DEVELOPMENT REVIEW COMMITTEE

February 20, 2023

580 BRINY AVENUE APARTMENTS – Site Plan

Request: Major Site Plan
P&Z Number: 22-12000043
Owner: Claridge Homes Beachboys LP
Project Location: 580 Briny Avenue
Folio Number: 494306060260
Land Use Designation: Medium-High (MH 16-25 DU/Acre)
Zoning District: RM-20/AOD (Multiple-Family Residential 20 /Atlantic Overlay District)
Commission District: Andrea McGee (District 1)
Agent: Andrew J. Schein
Project Planner: Diego Guevara (954-786-4310 diego.guevara@copbfl.com)

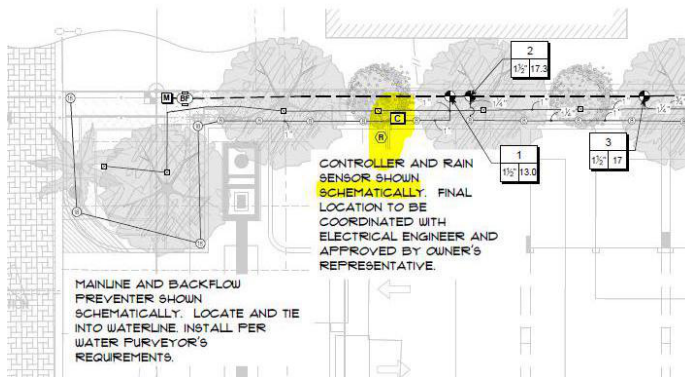
44. Staff requirement: Provide medium canopy trees in parking islands along rear drive aisle.

RESPONSE: Silver Buttonwood(4) provided in parking island.
